DOCUMENT - 2026-264T
Interior and Exterior Renovations at Peel Regional Police 12 Division, 4600
Dixie Road, Mississauga
ADDENDUM NO. 6

Referring to the above Document 2026-264T - Interior and Exterior Renovations at Peel Regional Police 12 Division, 4600 Dixie Road, Mississauga, please note the following:

A060

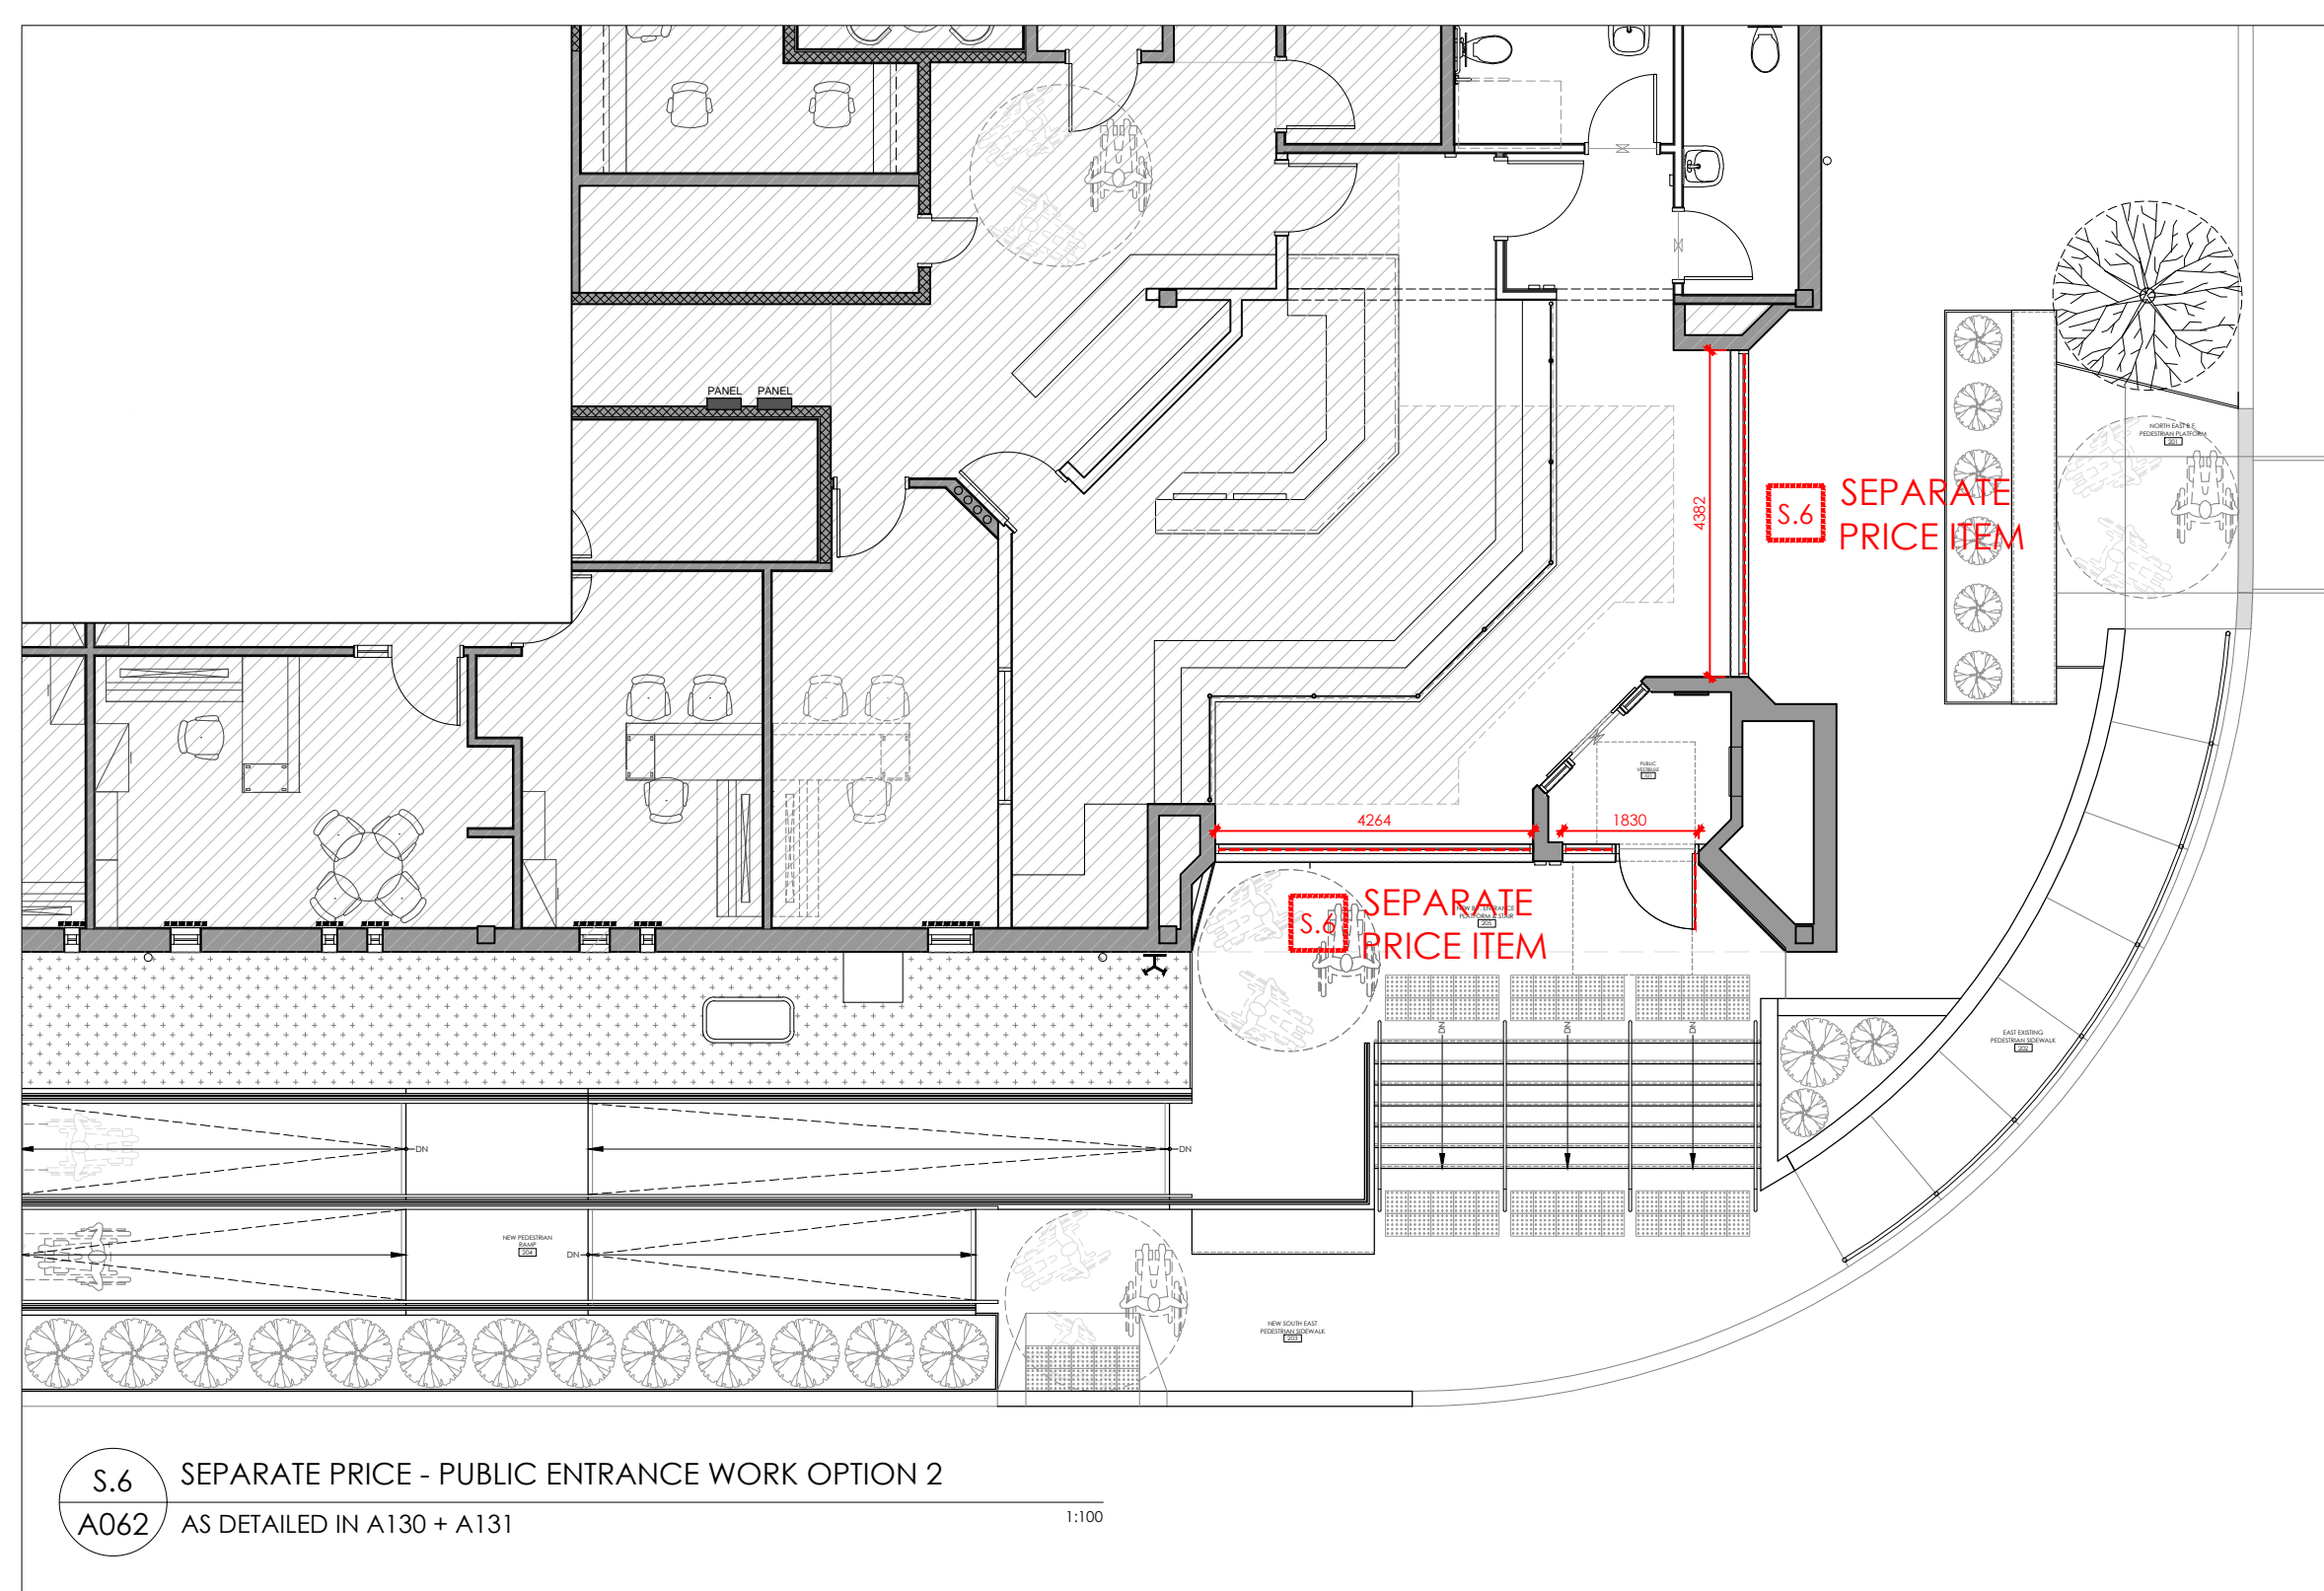
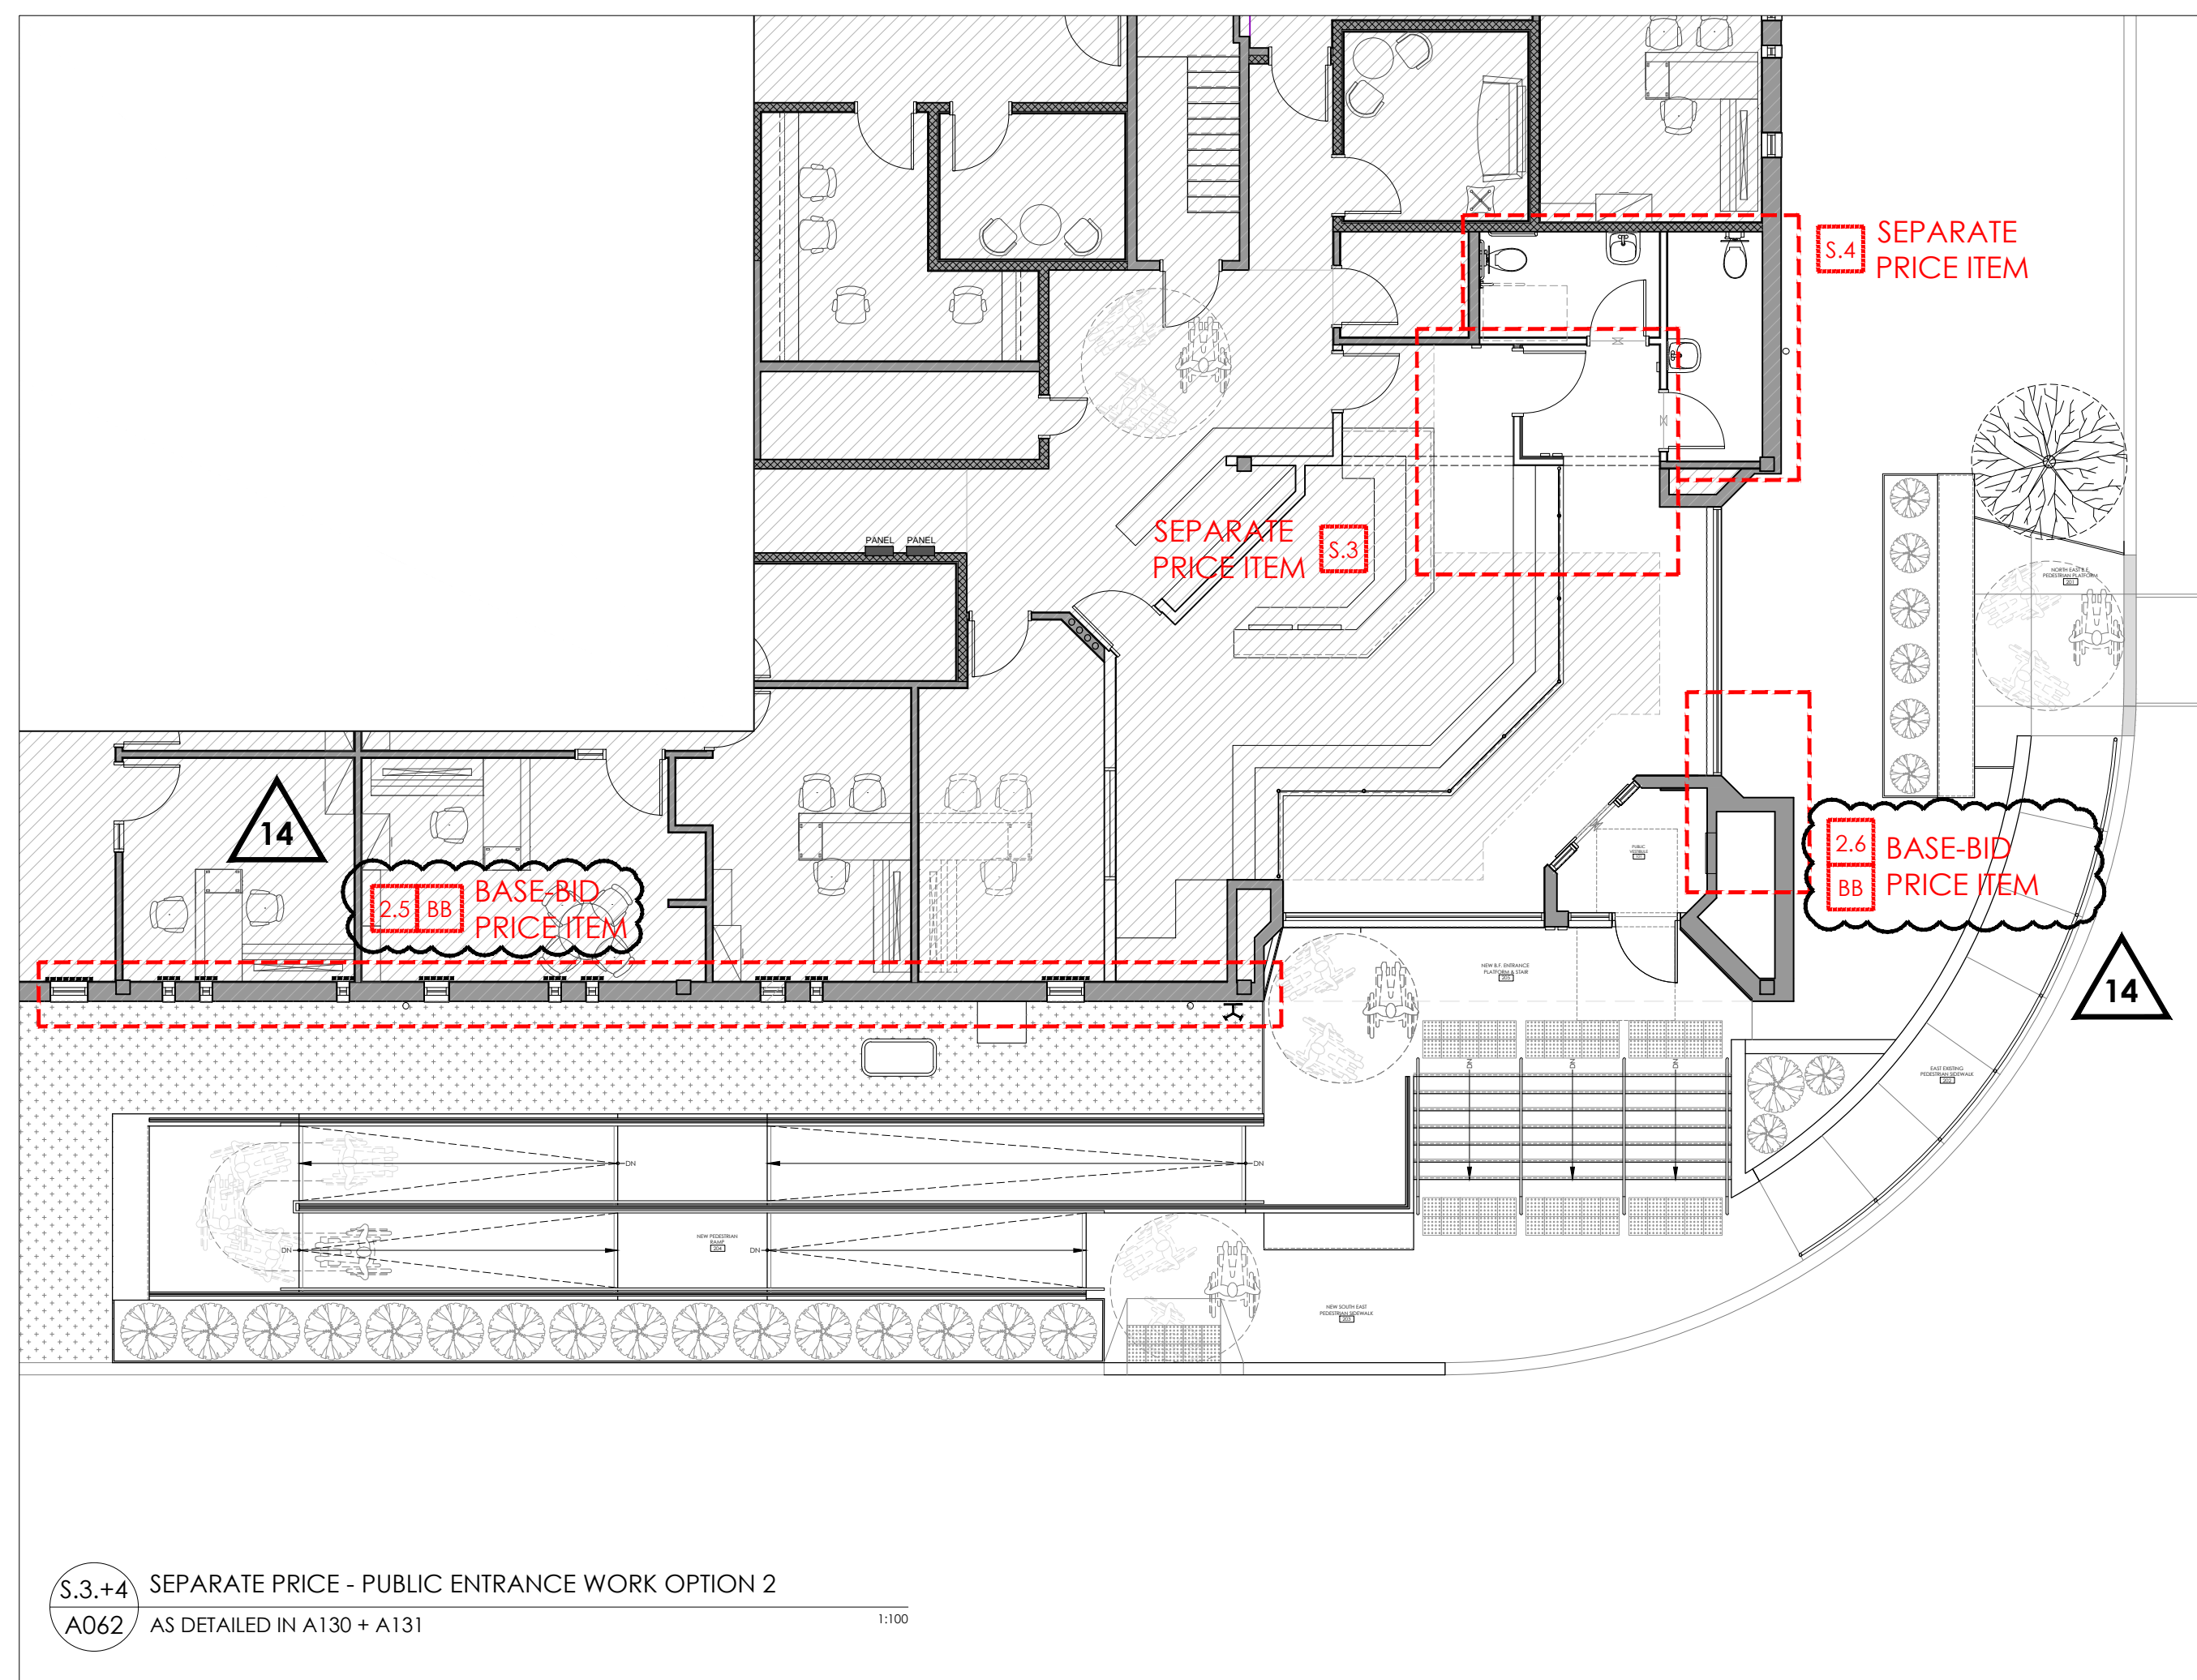
Drawing A060, Note 2.4 states: 'Demolition and removal of existing exterior site work and construction including sidewalks, stairs, and planter beds.' However, the Bid Form on Bid & Tender appears to request pricing only

for the demolition component under Base Bid Item 2.4. Please confirm whether Base Bid Item 2.4 is intended to include: Demolition and removal of the existing exterior site work; and Construction and reinstatement of new sidewalks, stairs, planter beds, and associated site works as indicated on the drawings.

Some phasing legends on A060 are overlapping and it's difficult to reach the numbers. Can you please fix it so that they can be read clearly.

Regarding Item 2.4 - Refer to Addendum 3, Question #5 & Addendum 5, Question #26. For Clarity, Item 2.4 - BB is limited to the removal of existing raised concrete planter beds only and has been reflected in the attached A060_R14 revision. Costs associated with the ramp construction and sitework should be included as Separate Price S.1.

Refer to the attached revised A060 (Note, no numbering has changed but overlapping labels have been fixed). Also, description for Item 2.4 has been modified to correspond with pricing item 4 on the Bid Form, Addendum 3 Question #5, & Addendum 5 Question #26.

A120

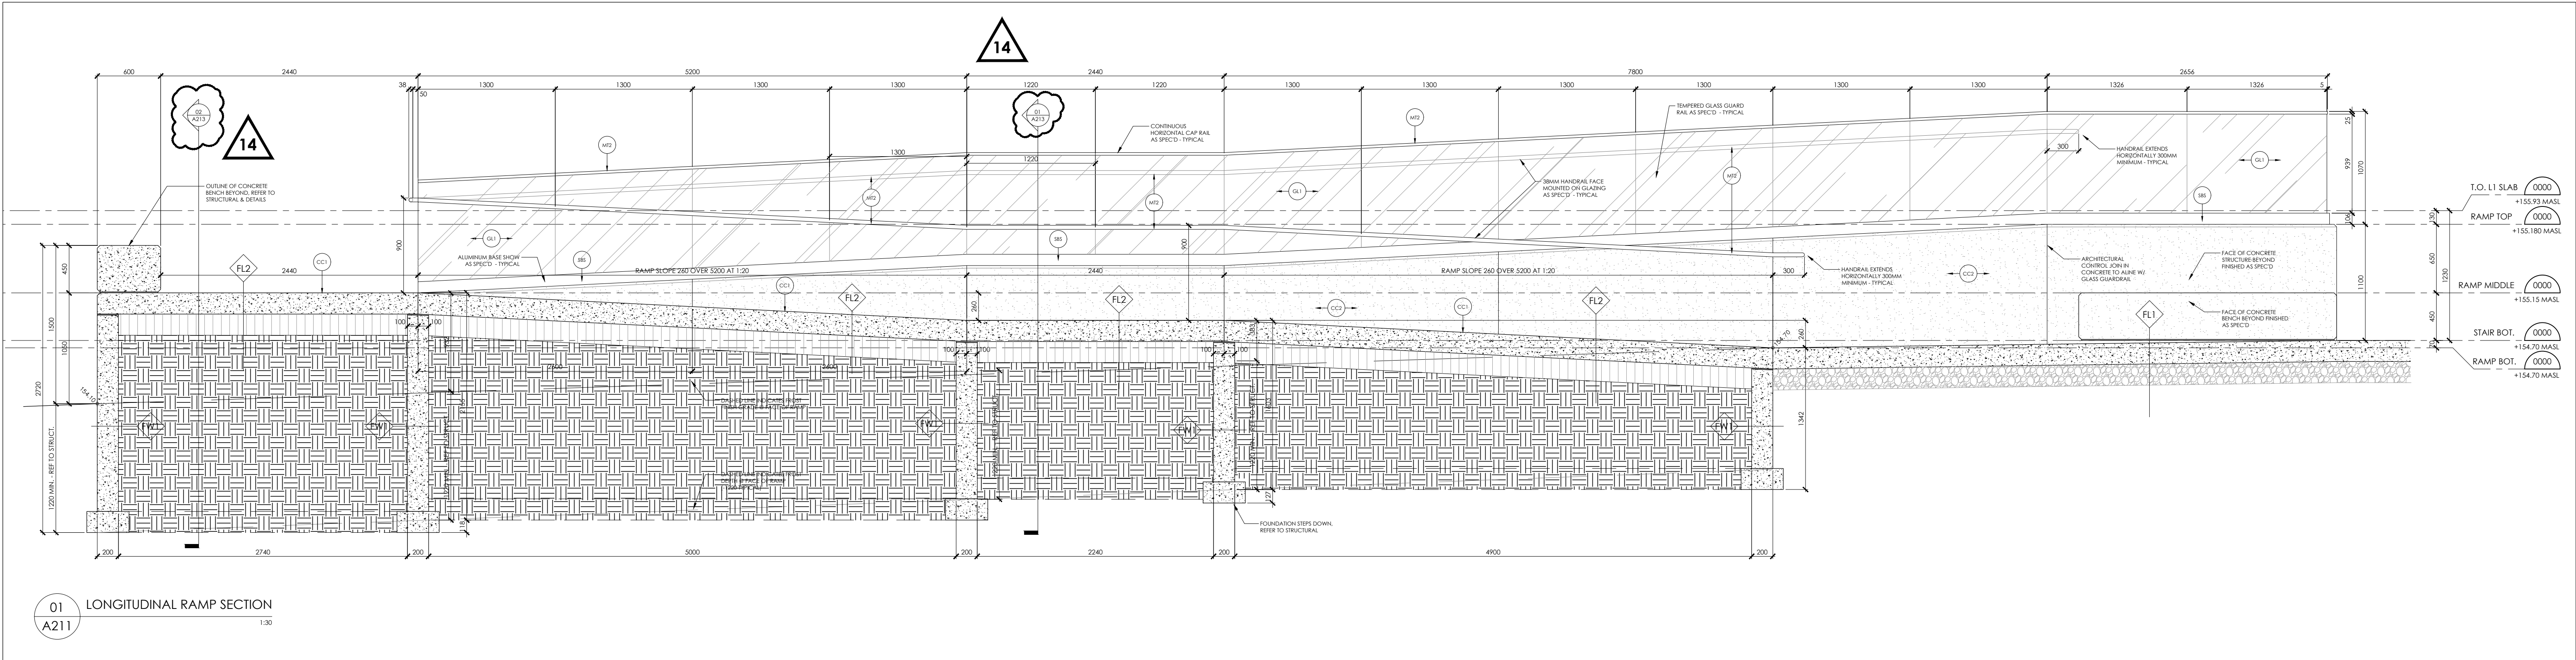
Drawing A120 references Section Detail 03/A210; however, upon review of Drawing A210, Section 03 does not appear to be included. Please clarify the intended section reference and provide the correct drawing/detail number or issue a revised drawing set identifying the applicable section.

Missing ramp sections have been added on A213. A120_R14, and A211_R14 have been revised for updated detail references.
